MARTIN S. BURCK ASSOCIATES, INC.

Subject: Response to January 5, 2023, Ecology Further Action Letter

North Star Casteel (Formerly Varicast Inc.)
1200 West 13th Street
Vancouver, Washington
VCP Identification: SW1712

FIGURE 1
1935 AERIAL IMAGE WITH
SAMPLE LOCATIONS
North Star Casteel Property
1200 West 13th Street
Vancouver, WA 98660

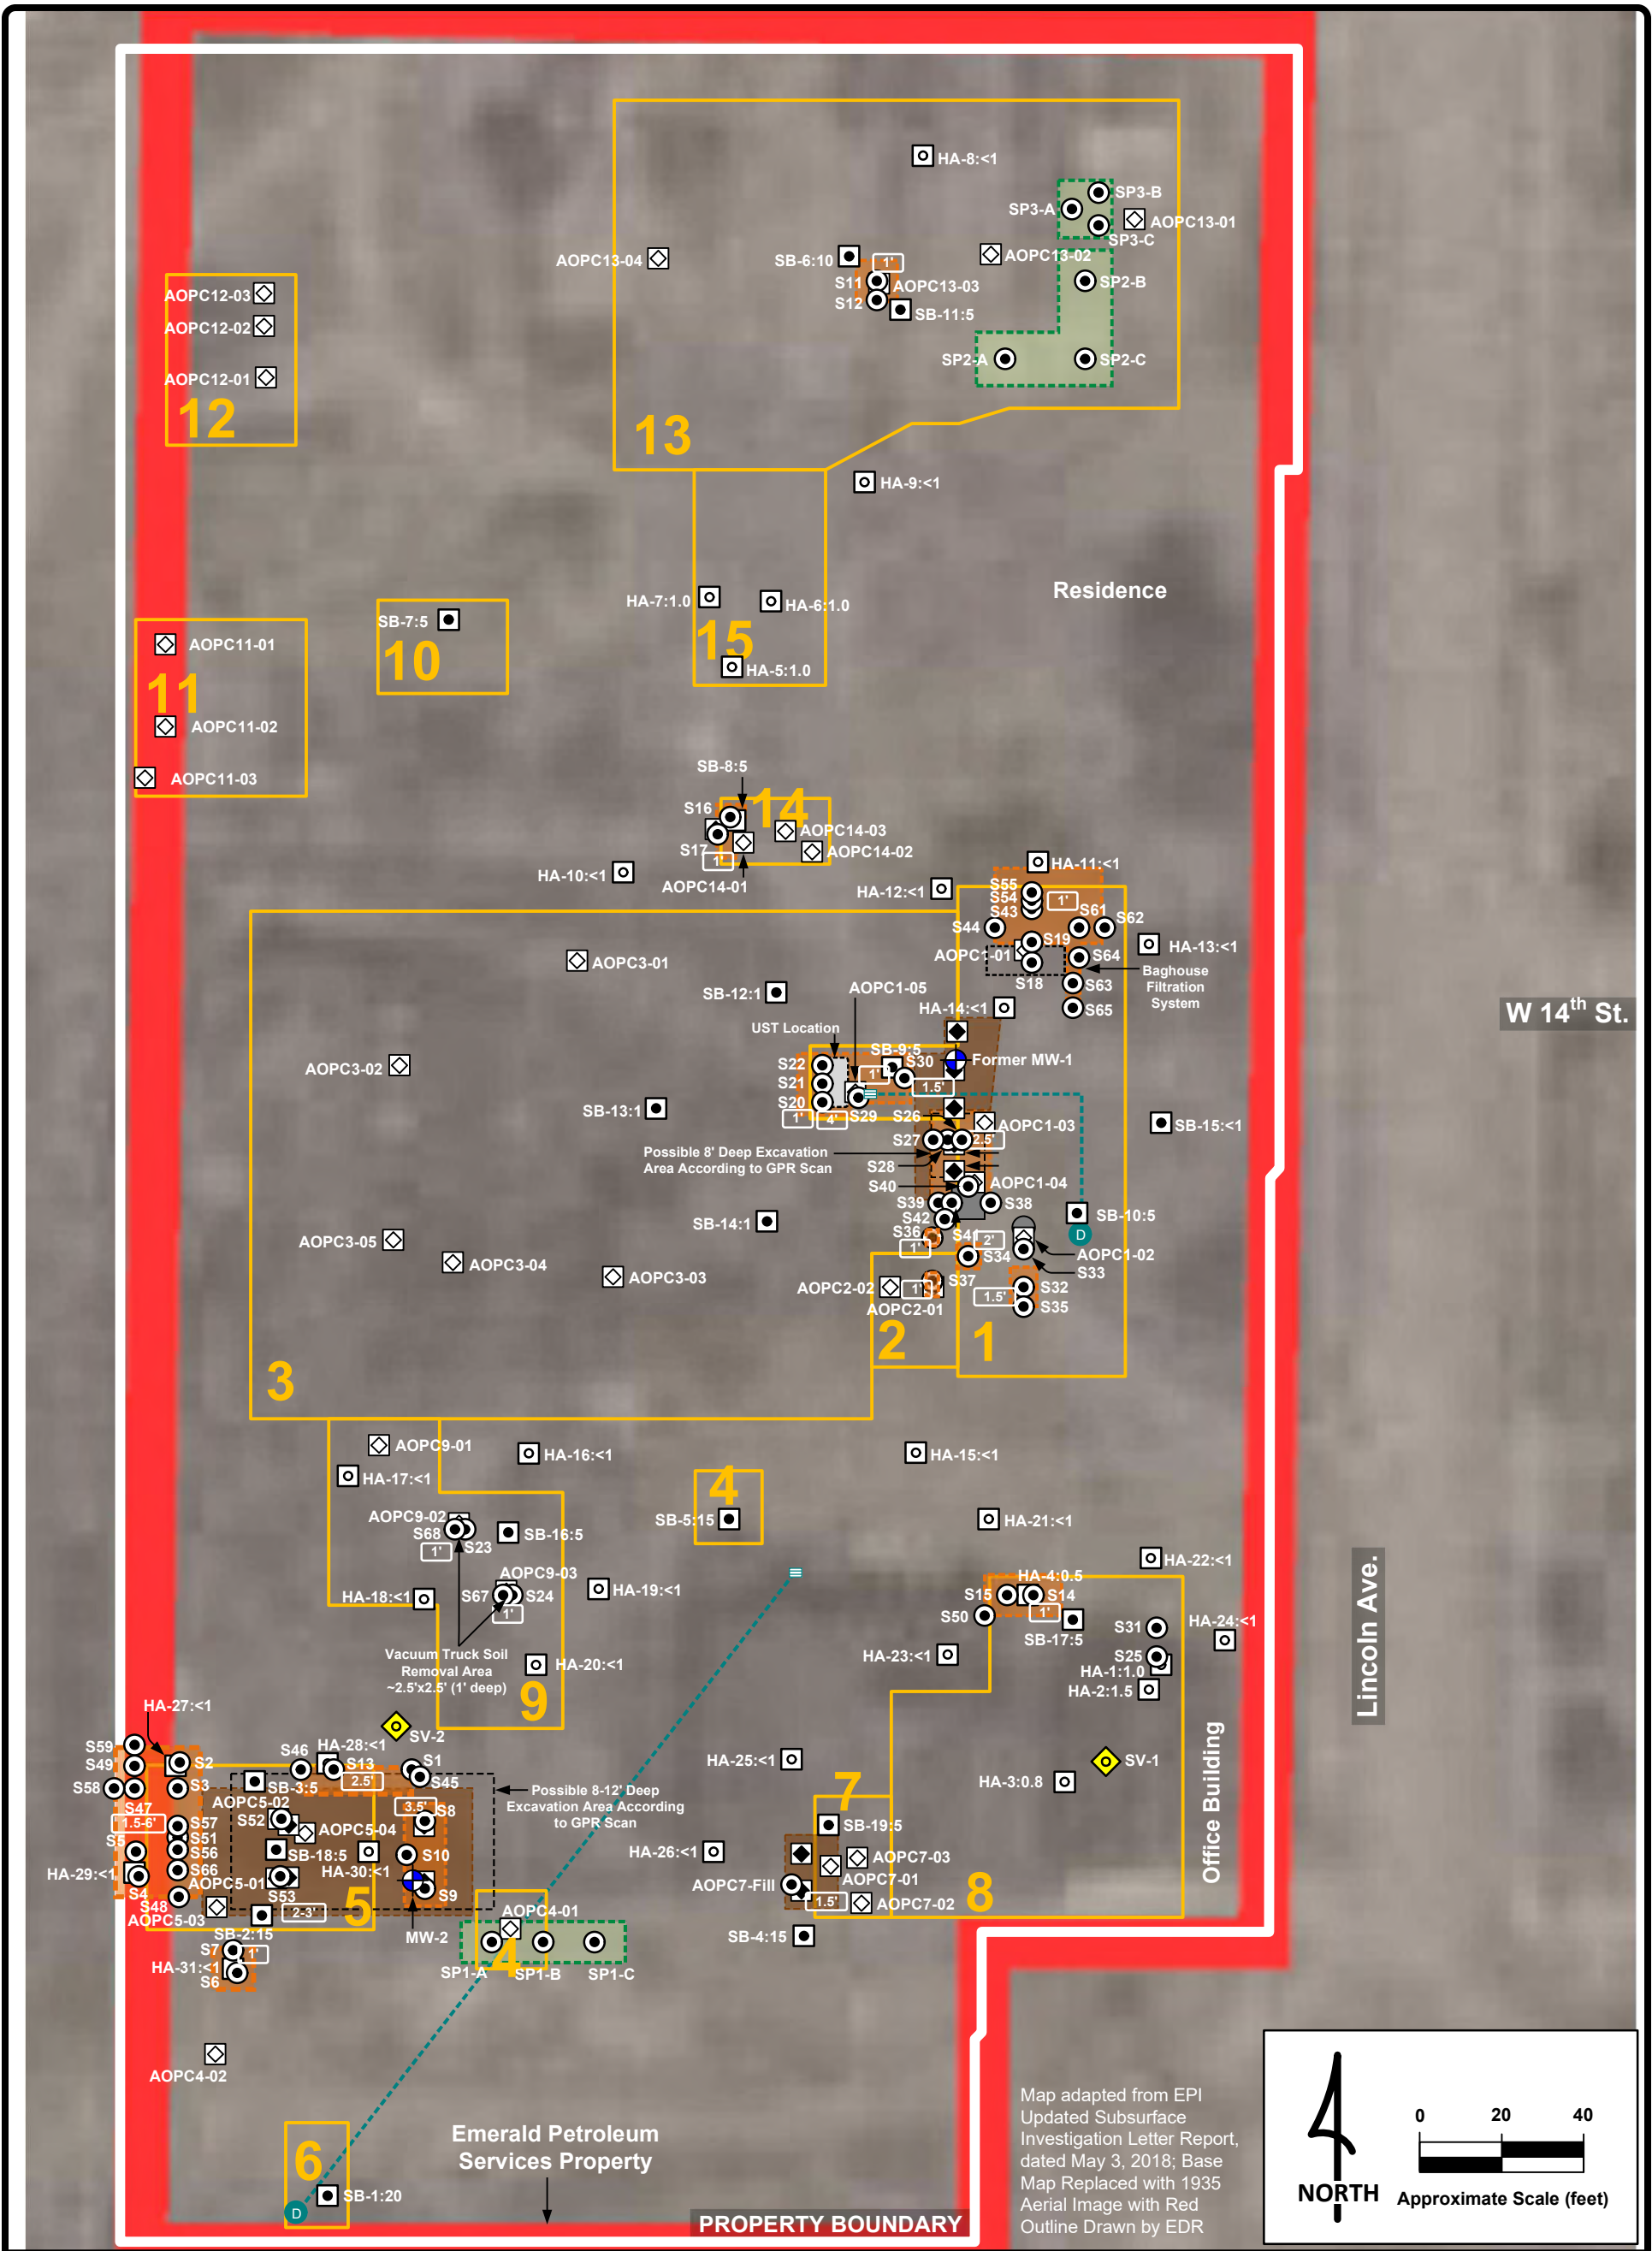
- ***1935:*** Maintenance Building present. Long large rectangular building present adjacent to western Site-boundary occupying southern perimeter—may have extended on-Site. Circular line of what appears to be large ASTs or silos aligned north-south at west end of what is now foundry building. Structure at northeast corner.

MSBA: EPI completed Phase I and Phase II Environmental Site Assessments at the site, which included an EDR Environmental Database Report and a detailed review of the site history, aerial photographs, and historic uses. MSBA reviewed EPI's methods and findings and concluded that the investigation was thorough. The "long large rectangular building" you refer to is present on a 1928 Sanborn map (Attachment C) and is labeled California Packing Corporation Plant. This building is located west of the site boundary some distance and does not overlap. It is also at a lower level than the site with a railroad spur and a steep embankment separating the two. The nearby foundry building was also present in 1928 (Sanborn map). Due to the poor quality of the 1935 aerial photo and the red EDR outline, the west side of the foundry is obscured and the building itself is difficult to discern.

The circular features you mention as possible ASTs or silos, are well within the footprint of the foundry building and may represent cupolas protruding through the roof for passive ventilation. Cupolas are also labeled on the 1928 Sanborn map and were commonly used in foundries to allow heat to escape through the ceiling/roof. In addition, it appears that sample AOPC3-02 was collected at the approximate location you're describing (Attachment D). The approximate sample locations are depicted on the 1935 aerial photograph presented in Attachment D. In our opinion, the sample coverage is sufficient and meets the criteria for an investigation based on the former site features and site utilization as described. The larger off-site structure to the northeast is labeled as prune storage on the 1928 Sanborn map

and was not related to the foundry. The structures at the north end of the site are residences based on the presence of residences at that general location on the 1928 Sanborn map and a notable increase in residences shown on the 1966 Sanborn map.

FIGURE 2

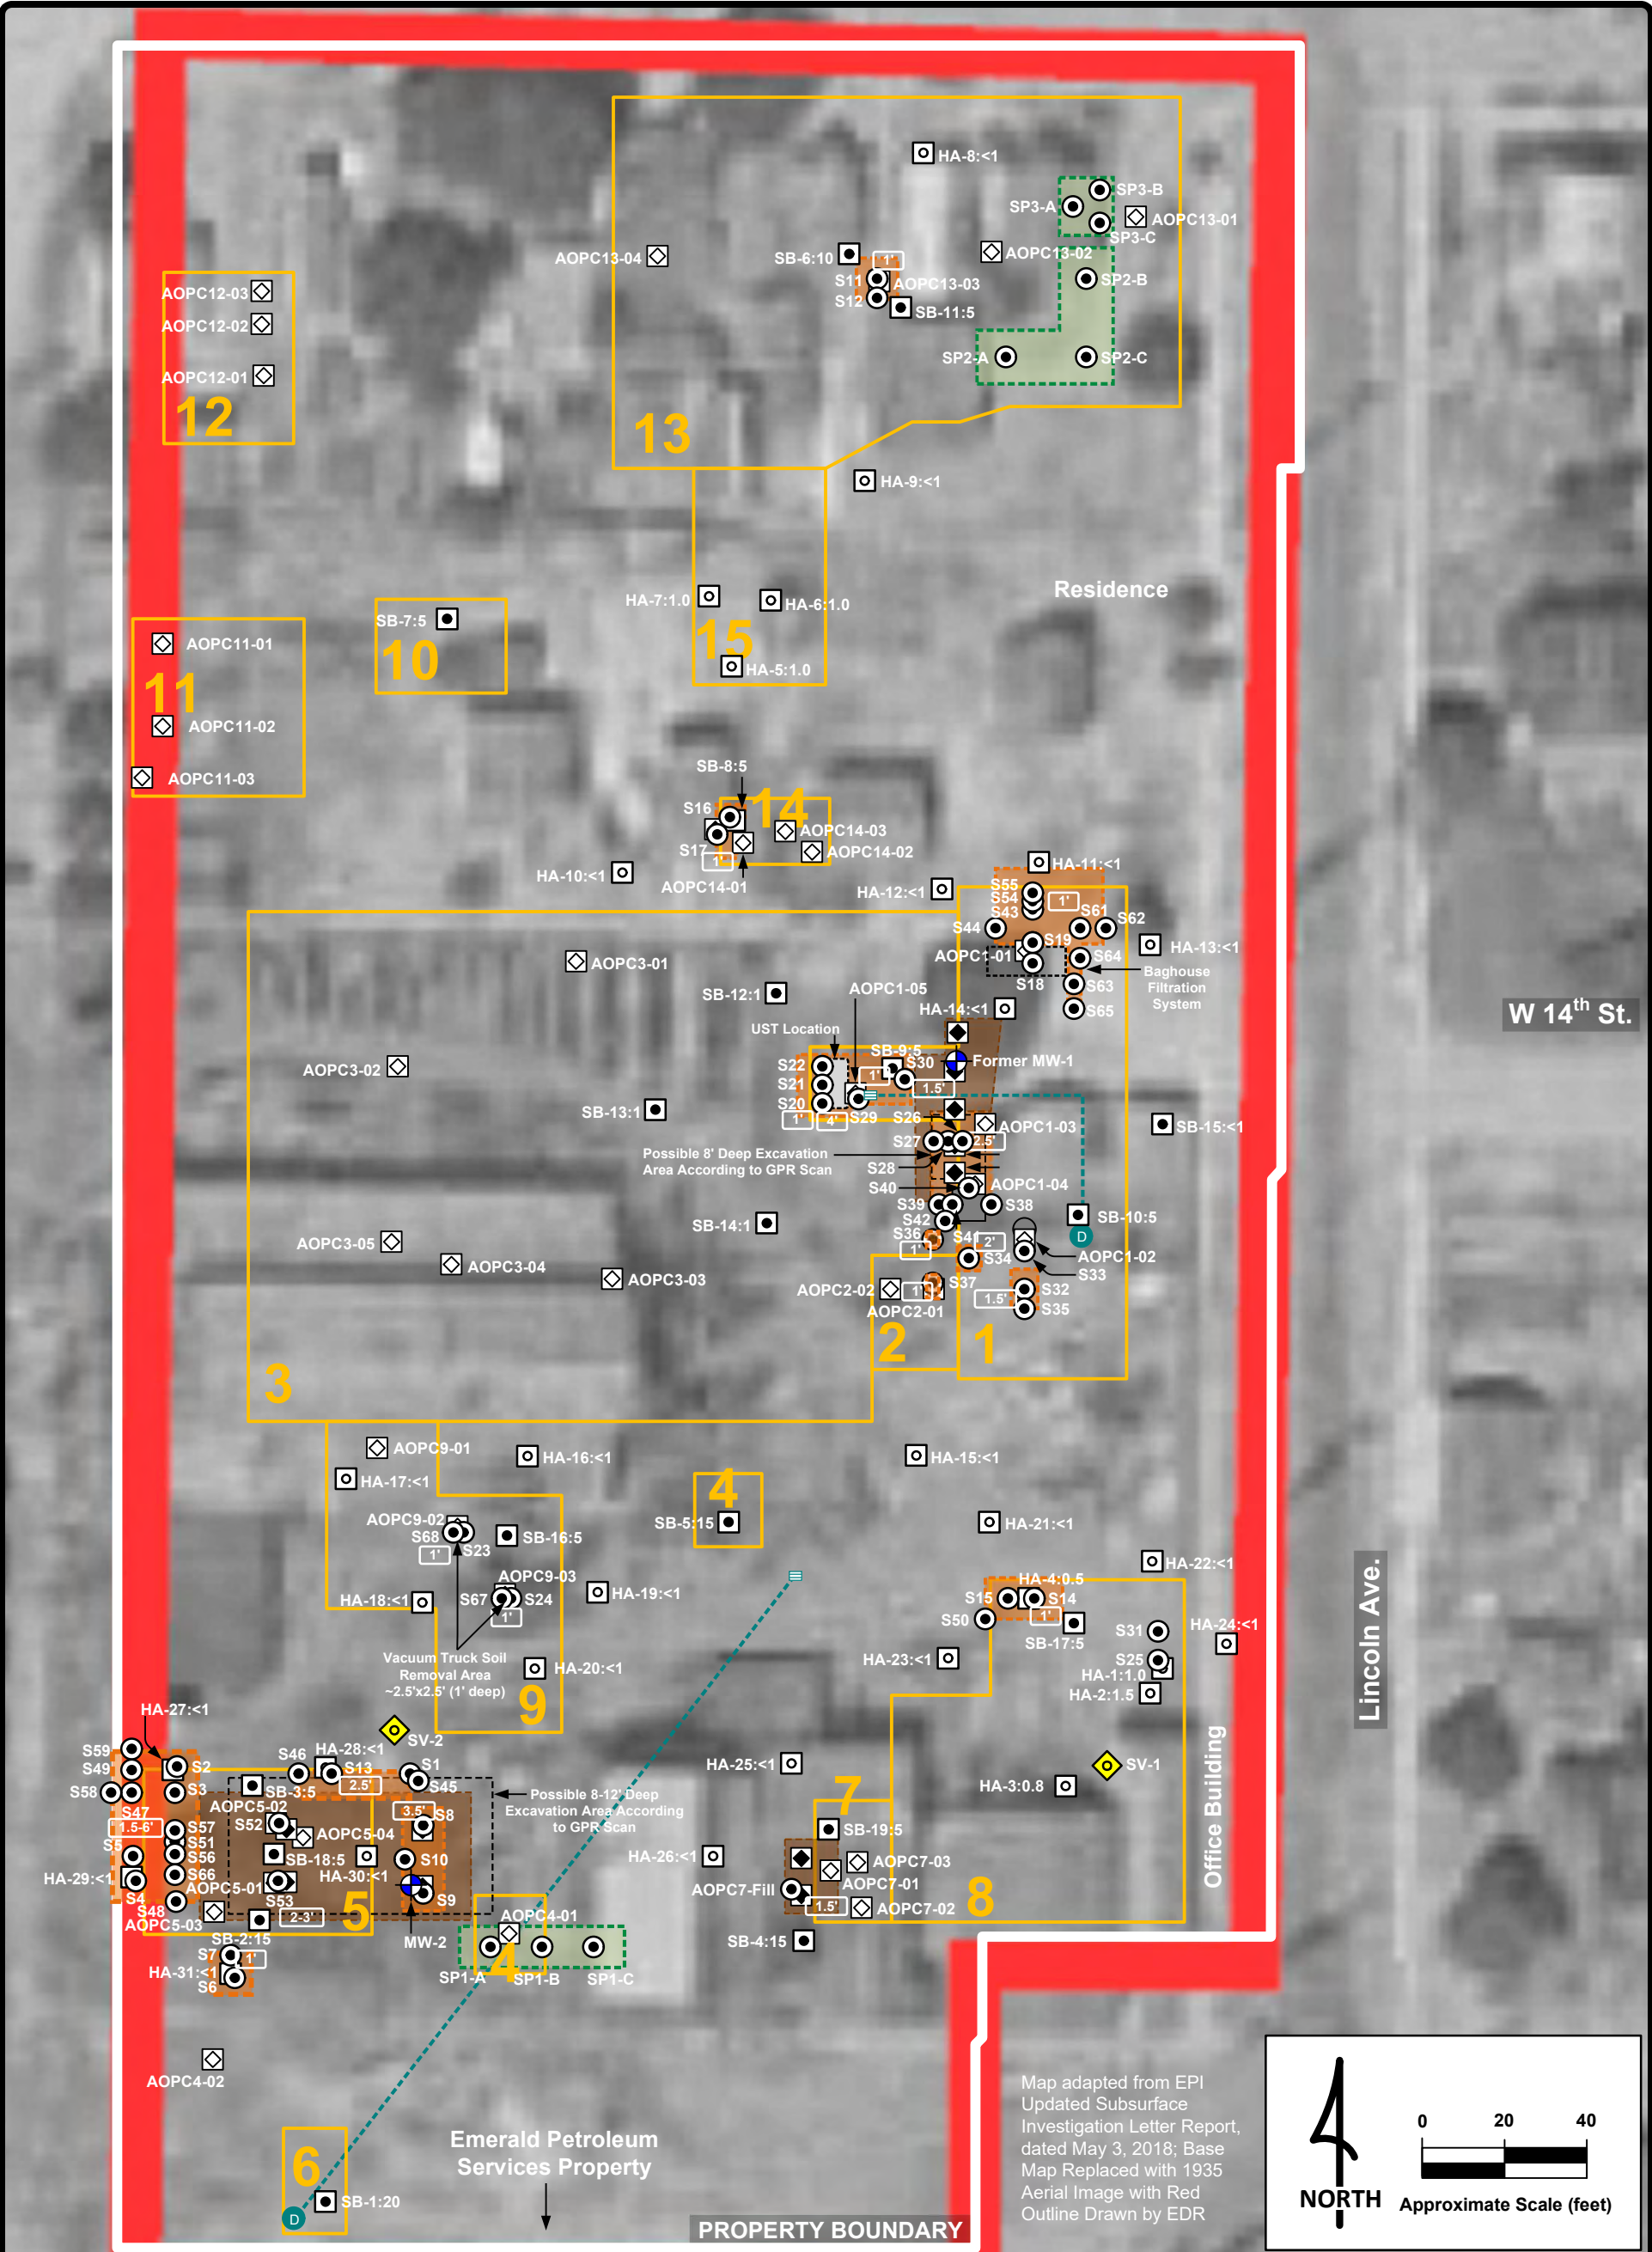
- **1948:** Another north-south oriented building just west of AOPC 8 (Maintenance Shop Building) occupying area of Site that is now vacant between AOPC 5 (Southwest Compressor) and AOPC 8—no investigation there to date.

MSBA: An overlay of the approximate sample locations depicted on the 1948 aerial is presented in Attachment D. Sample HA-26 was collected in the vicinity of the building described. The building looks to be in a similar location to the one depicted on the 1928 Sanborn map, which is labeled as Interstate Manufacturing Company, Pattern Shop and Woodworking. In our opinion, the former presence of a building does not warrant any additional investigation.
